United States Department of the Interior

Subject Draft Environmental Impact Statement (DEIS) for the Proposed Atlantic Coast Pipeline, Supply Header Project, and Capacity Lease Proposal, FERC No. CP15-554-001, CP15-555-000 and CP15-556-000, various counties in Pennsylvania, West Virginia, Virginia and North Carolina.

The Department of the Interior has reviewed the DEIS by the Federal Regulatory Commission for the proposed Atlantic Coast Pipeline (ACP) and Supply Header Project (SHP) received on January 4, 2017. This memo is intended to inform readers of potential disturbance of USGS streamgages as well as concern for water quality, public water supply, construction risks to water resources in karst and steep slope conditions, and ecological stream flows.

Review Figure 1. Atlantic Coast Pipeline route and USGS stations within one mile of proposed route, or known access roads.

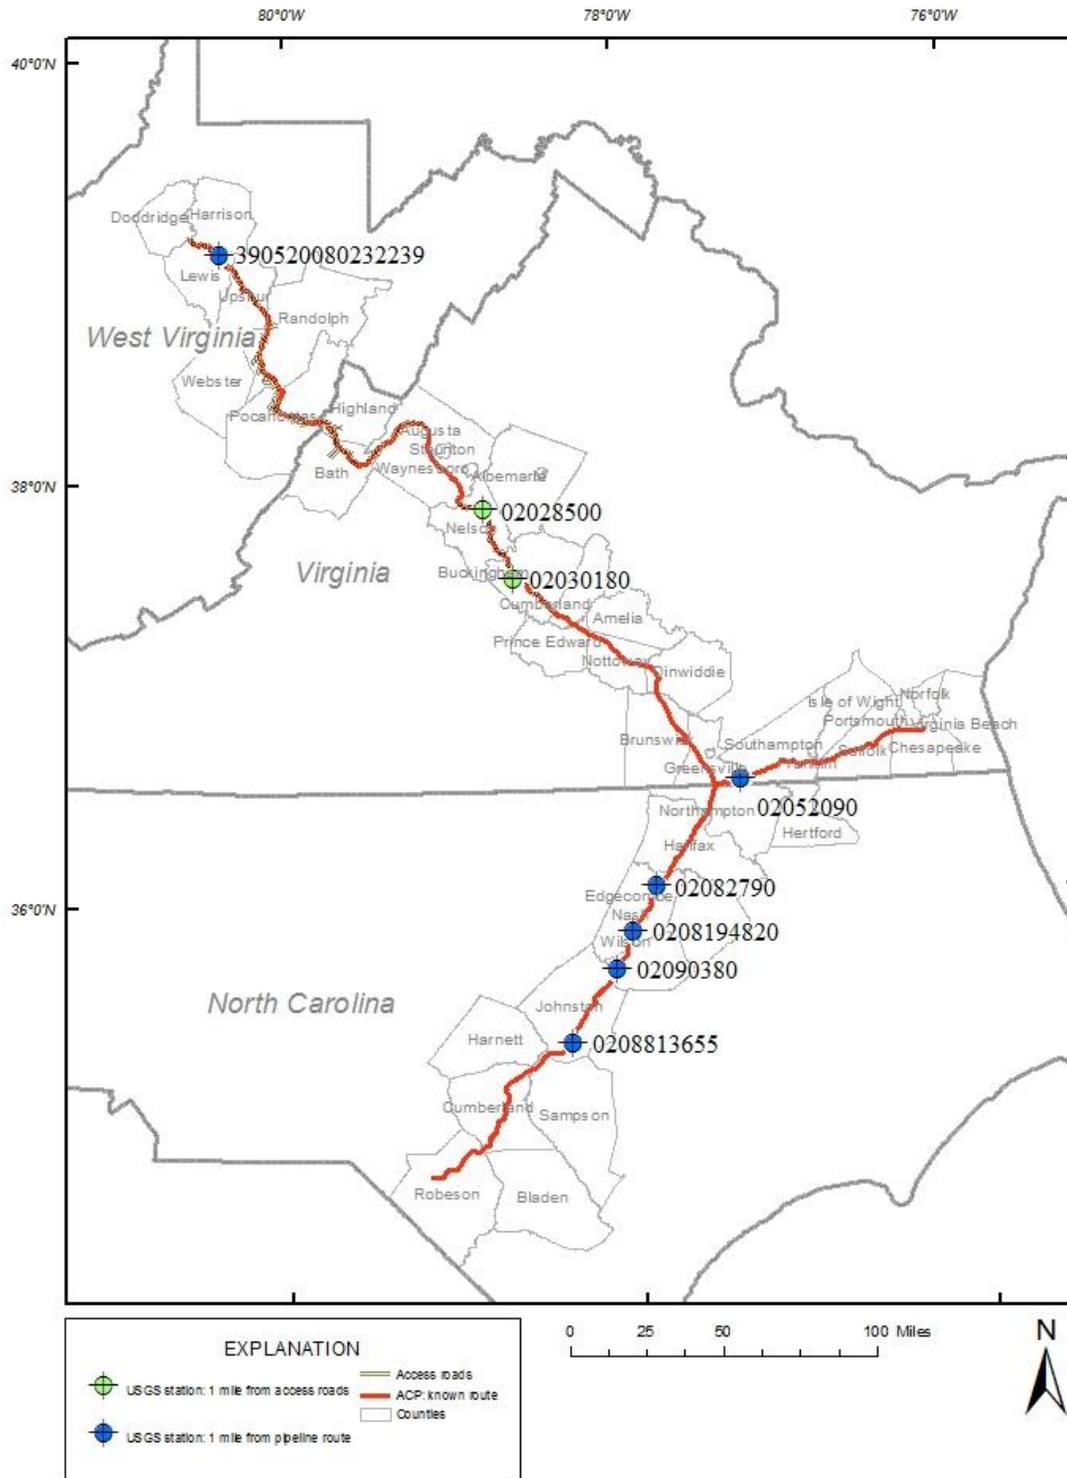
COMMENT: USGS Streamgaging

The USGS operates streamgaging and water quality stations along streams throughout the U.S. to collect water quantity and quality data for a variety of purposes. Unimpeded operation of USGS streamgages is essential for our stakeholders. Streamgages have permanent infrastructure and are vulnerable to disruption when significant construction occurs close to these stations. Some streamgages are used intermittently. The table and review figure 1 (below) show information on active USGS streamgages, or sites where there was an active streamgage within the last 10 years, within one mile of the known pipeline route or access roads in Virginia. USGS Water Science Centers in Virginia, West Virginia, and North Carolina should be notified prior to construction near these sites.
